SEARS

NAVIX PROJECT NUMBER: 50-215-004

7414 78TH AVE SE
MERCER ISLAND, WA 98040

ENGINEERS' CONSTRUCTION RECORD CERTIFICATION

C6.01

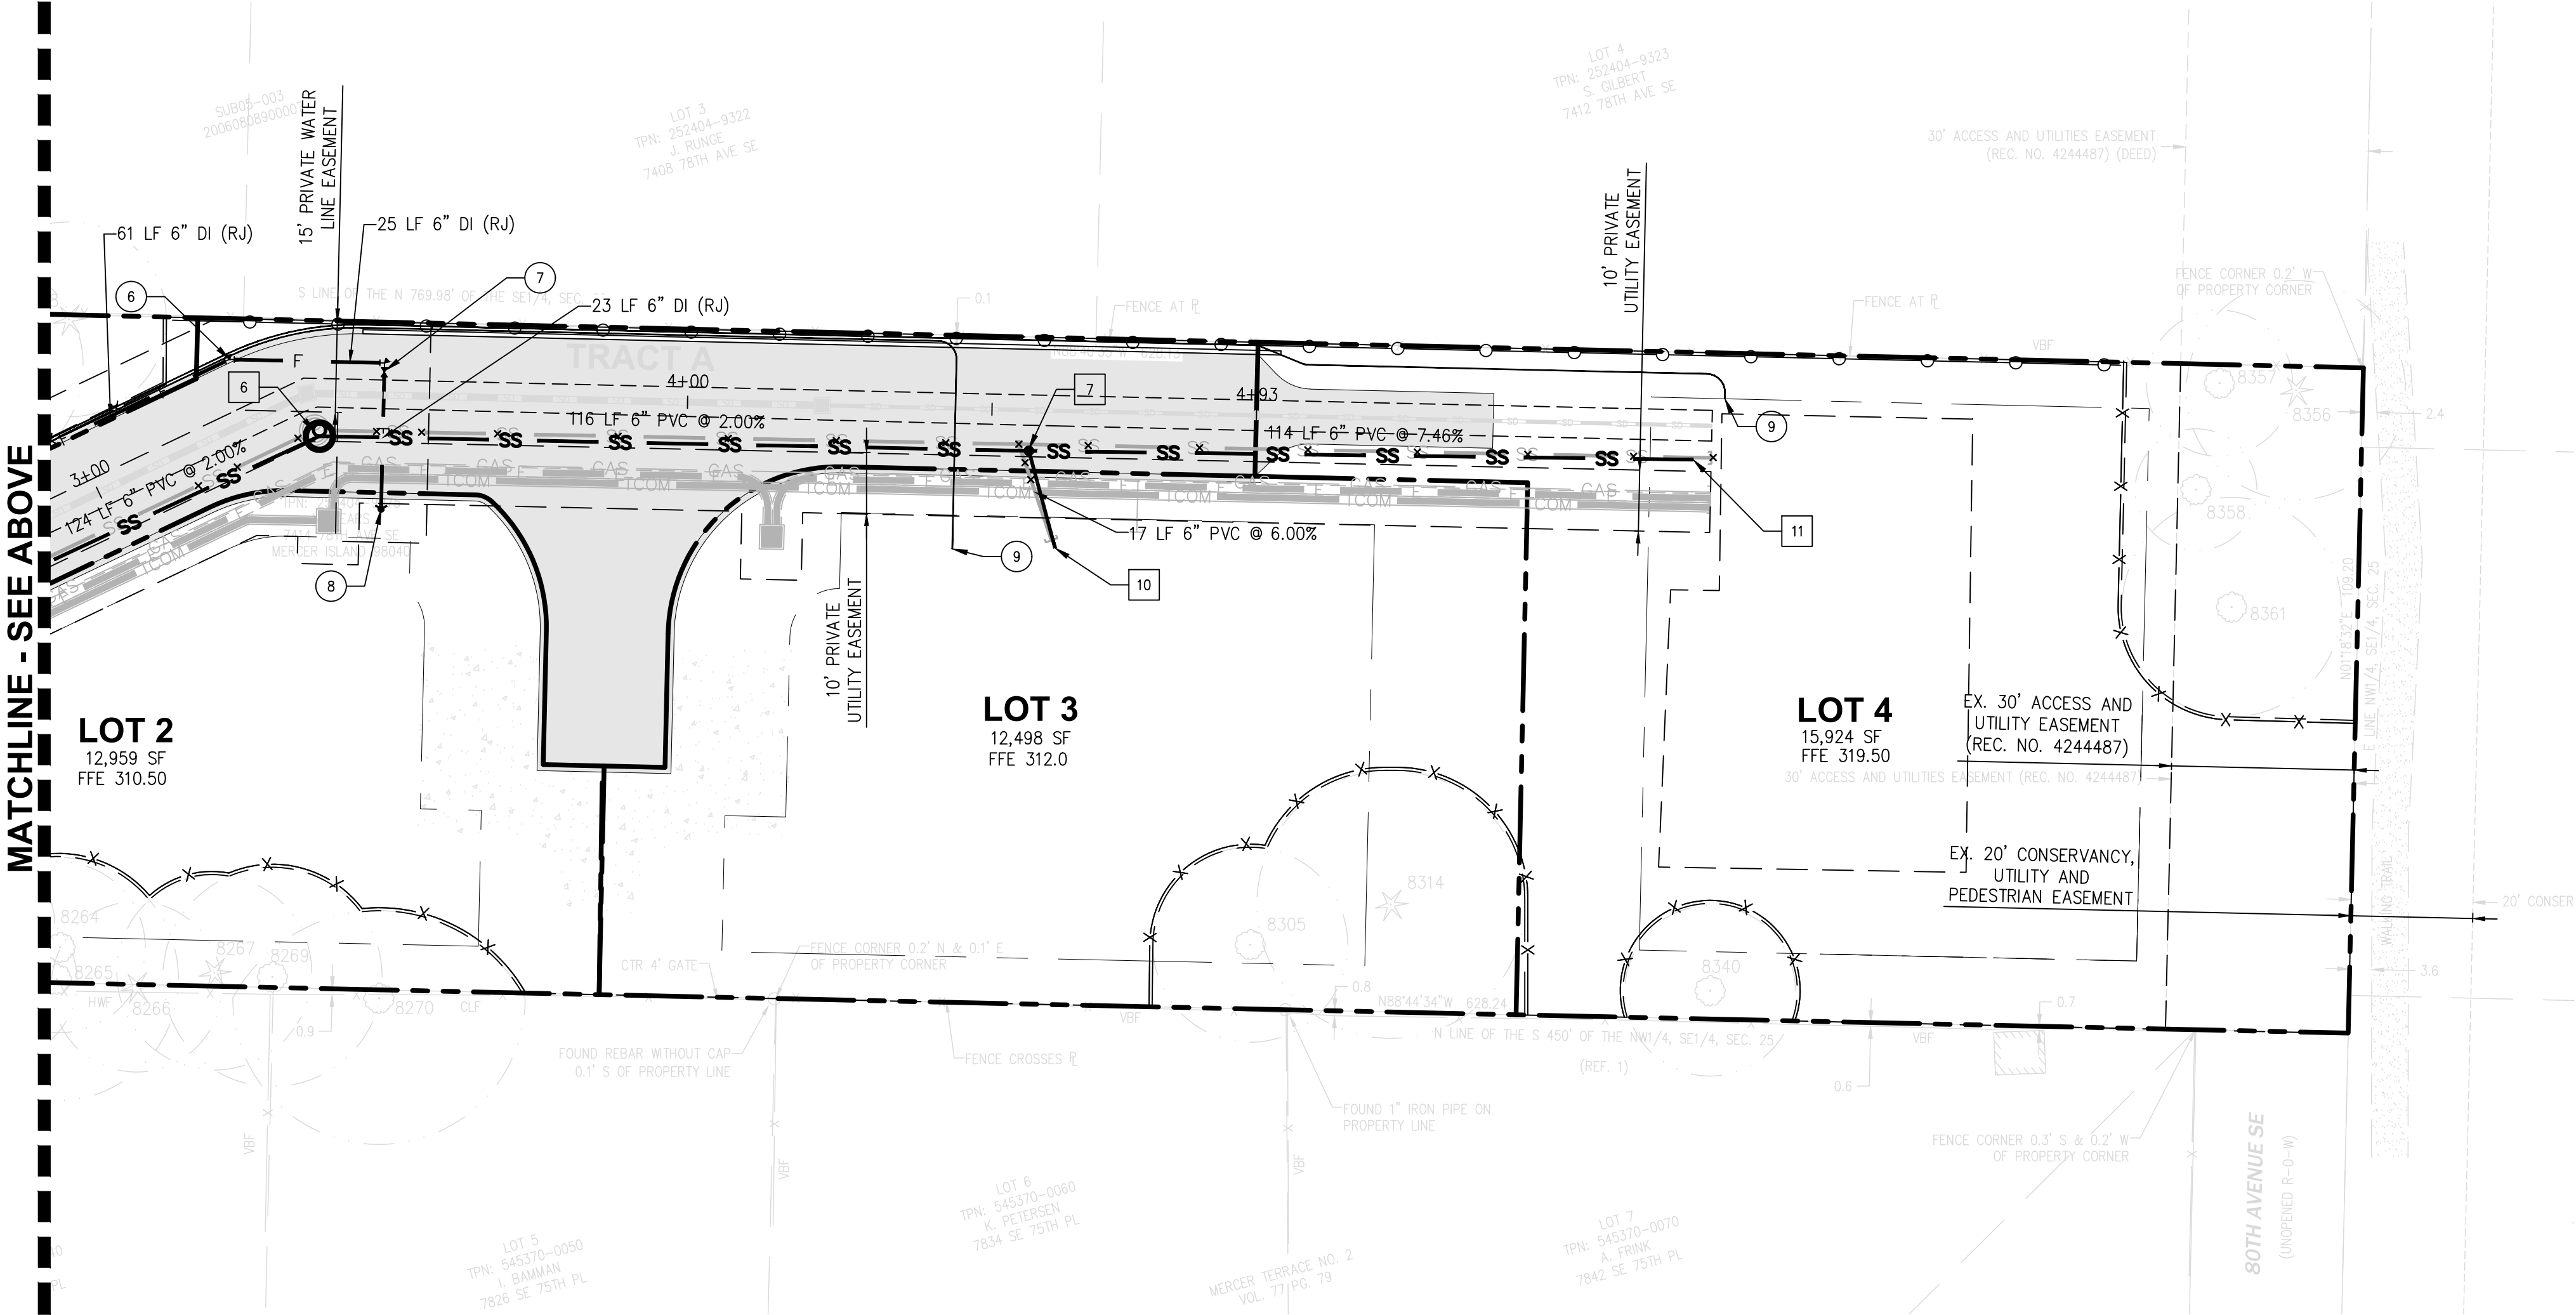
1	EX. SS CONN. TO MAIN N:198695.04 E:1294164.68 8" IE: 285.35 6" IE: 285.40	7	SSCO #4 N:198771.52 E:1294610.03 RIM: ~~312.34~~ 312.19 6" IE: 305.07 (E) 6" IE: 305.07 (S) 6" IE: 305.07 (W)
2	CONN. TO EX. SS STUB SEE NOTE 4. N:198688.43 E:1294275.71 6" IE: 296.84 CONTRACTOR TO FIELD VERIFY IE SEE NOTE 4.	8	LOT 1 SS STUB WITH CAP AND MARKER POST N:198728.22 E:1294314.69 6" IE: ~~297.98~~ (S) 298.26
3	SSCO #1 N:198692.82 E:1294300.48 RIM: 303.23 6" IE: 297.15 (NE) 6" IE: 297.35 (E) 6" IE: 297.33 (W)	9	LOT 2 SS STUB WITH CAP AND MARKER POST N:198719.60 E:1294426.71 6" IE: ~~304.06~~ (W) 304.50
4	SSCO #2 N:198692.42 E:1294323.68 RIM: ~~305.01~~ 305.83 6" IE: 298.75 (NE) 6" IE: 298.76 (W)	10	LOT 3 SS STUB WITH CAP AND MARKER POST N:198755.74 E:1294615.39 6" IE: ~~306.07~~ (N) 306.37
5	SSCO #3 N:198720.64 E:1294382.88 RIM: 305.90 6" IE: 300.06 (NE) 6" IE: 300.04 (E) 6" IE: 300.06 (SW)	11	LOT 4 SS STUB WITH CAP AND MARKER POST N:198769.27 E:1294723.72 6" IE: ~~313.55~~ (W) 313.10

6	SSMH #1 (48") N:198773.82 E:1294434.44 RIM: ~~308.75~~ 308.73 6" IE: ~~302.76~~ (E) 302.63 6" IE: ~~302.53~~ (SW) 302.53	12	SSCO #5 N:198773.82 E:1294434.44 RIM: ~~308.75~~ 308.73 6" IE: 297.55 (N) 6" IE: 297.55 (SW)

1	1-2" TAPPING TEE PER DTL. W-14 6 LF 2" PE WATER LINE
2	1-1.5" DOMESTIC WATER/FIRE METER PER DTL. W-14 1-STEEL METER BOX PER DTL. W-17 1-2" CORP. STOP 10 LF 2" PE WATER LINE
3	~~1-PRIVATE DOUBLE CHECK VALVE ASSEMBLY (DCVA) IN BELOW GRADE UTILITY BOX~~
4	1-6" TAPPING TEE PER DTL W-11
5	1-6" DCVA IN OLDCASTLE 687-LA VAULT PER DTL W-19 AND W-19A
6	1-6" 22.5' BEND THRUST BLOCKING PER DTL. W-5A
7	1-6" 90' BEND THRUST BLOCKING PER DTL. W-5A 1-6" GATE VALVE (FLxMJ)
8	1-FIRE HYDRANT ASSEMBLY PER DTL. W-24 1-4" STORZ ADAPTER THRUST BLOCKING PER DTL. W-5A
9	1-2" DOMESTIC WATER LINE STUB WITH MARKER BOARD FOR FUTURE CONNECTION
10	1- 6" 11.25' BEND THRUST BLOCKING PER DTL. W-5A
11	1-6" 45' BEND THRUST BLOCKING PER DTL. W-5A
12	1-6" POST INDICATOR VALVE
